From: s 36
To: [redacted]
Subject: RE: NBES visit
Date: Monday, 17 April 2023 10:24:54 PM
Attachments: [image001.png](#)
s 38

From: s 36 [REDACTED] >
Sent: Wednesday, 12 April 2023 10:11 AM
To: [REDACTED]@stategrowth.tas.gov.au>; [REDACTED]
[REDACTED]@stategrowth.tas.gov.au>; s 36 [REDACTED]
[REDACTED]
Cc: s [REDACTED]
Subject: RE: NBES visit

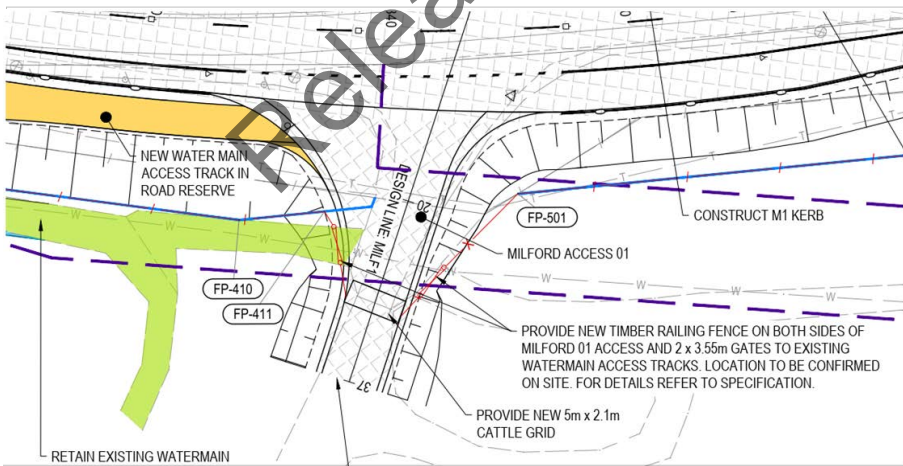
The snippet from sheet 1112 below reads to me like we're not providing a gate to the Milford driveway, only new 3.55m gates to each access track. Does the note below need to be updated to provide a gate on the Milford fence driveway?

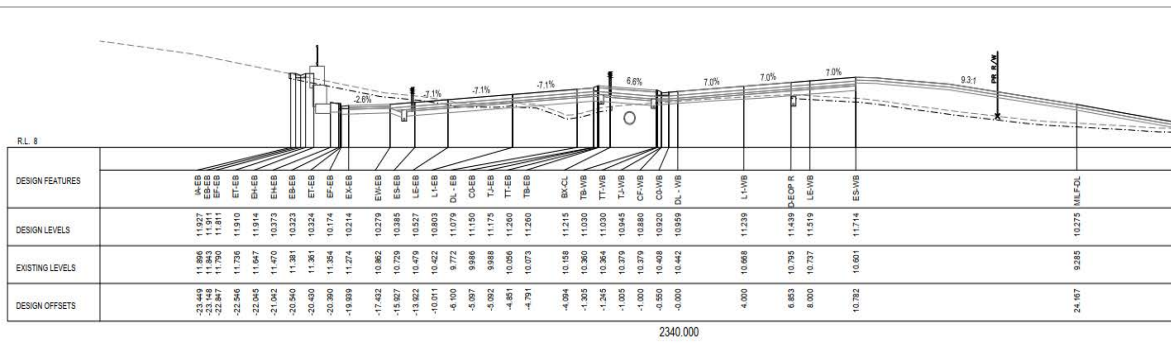
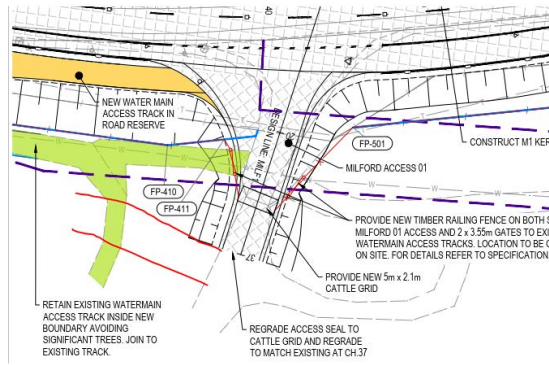
The photo attached is of the current access track to Milford driveway tie in. Looking at the cross section, the new driveway is over 1m higher than current one in sections before it ties into the existing. At what point along the cross section does the access track meet the new driveway (can you put a mark on the snippet below)? Are we planning on building up the access tracks on either side of the new driveway to offset the higher driveway? [REDACTED] concerns, which I would agree with seeing the cross section, is the increased gradient for the decent from the driveway onto the access track and increasing roll over opportunities.

In the survey you send there was a 'slashed line' that would put the access track in line with the access track on the other side of the drive, example below. Would it be simpler to put the access track as per [redacted] slashed track and move the gate to suit the new alignment?
